Maule Aircraft Corporation

20 August 1974

SERVICE LETTER #30

Subject: Right Side Exhaust System Hanger Brace

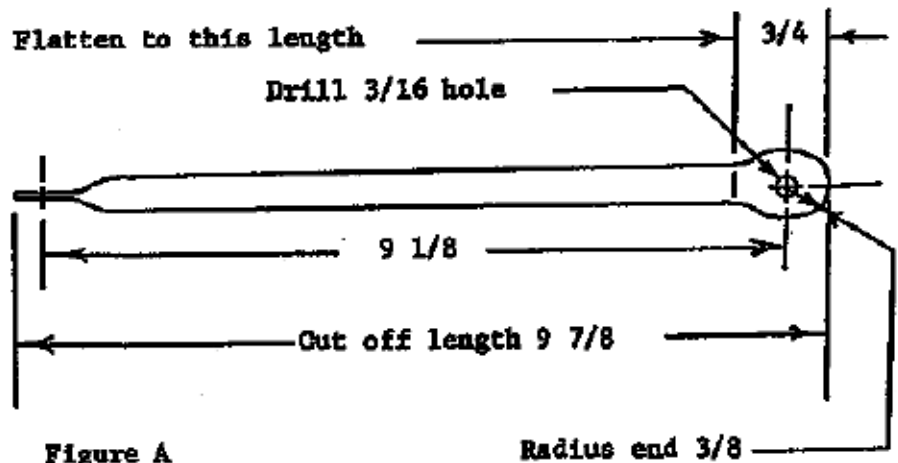
Background: Exhausts braced to the tab on the engine header stack put too much strain on the stack.

Description: If the Right Side Exhaust System is braced to the engine stack, remove the brace and rework it to the configuration shown in Figure A below. Attach it to the alternator mount by Bracket 5192 B-2 as shown in Figure B below.
